ADDENDUM NO. 2

TITLE: HUMPHREY PUBLIC SCHOOL POST TENSION TRACK AND FOOTBALL FIELD PROJECT
HUMPHREY PUBLIC SCHOOLS

PROJECT: REGA NO. 131295
BVH Project L13487

ENLARGED PLANVIEW w/OPTIONAL TURF LOCATION ONLY (ALTERNATE #7)

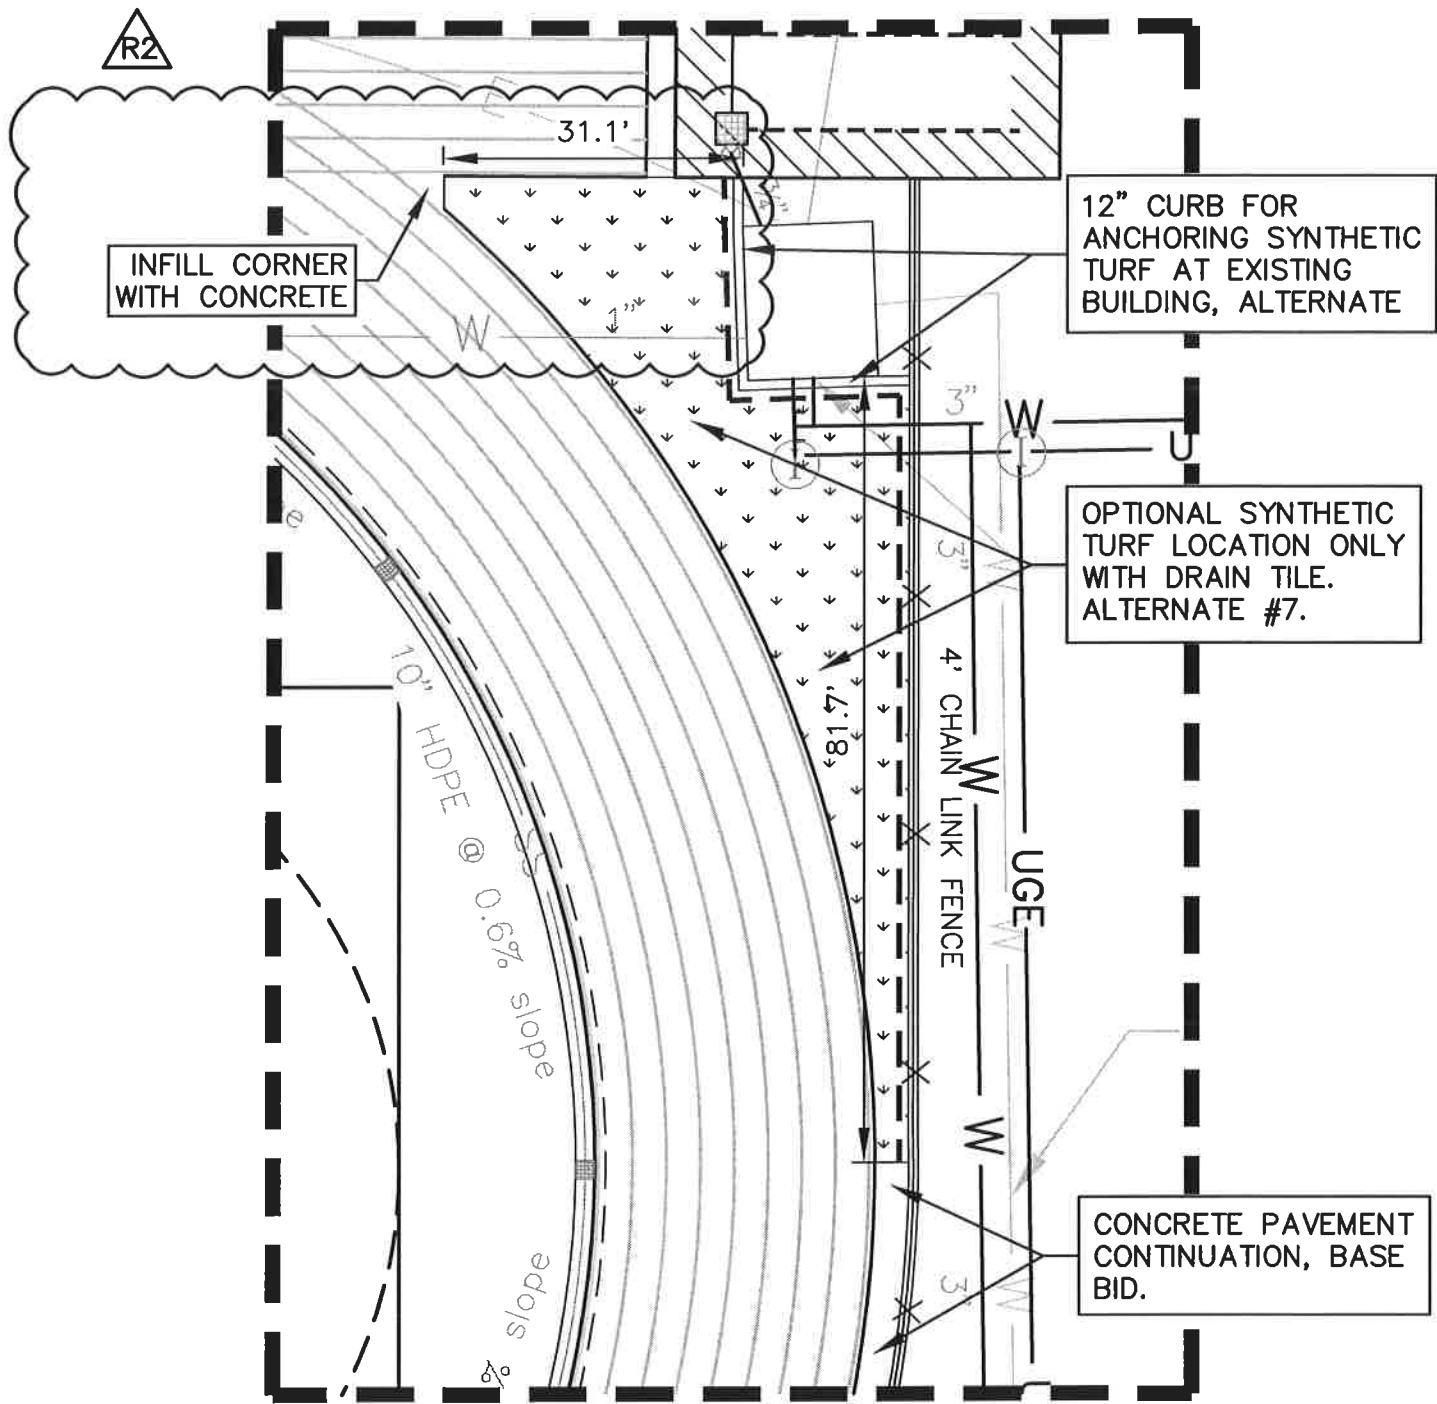
SHEET C1.2 ALT.

Delete: Enlarged planview w/optional turf location only. (Alternate # 7)

Add: Enlarged planview w/optional turf location only (Alternate # 7) in its' entirety. Concrete in fill shall include track surfacing per specifications.

ISSUED FOR:	DATE:	BY:
ADD. #2, REVISED ENLARGED PLANVIEW, ADD INFILL CORNER WITH CONCRETE.	10/30/14	SDB
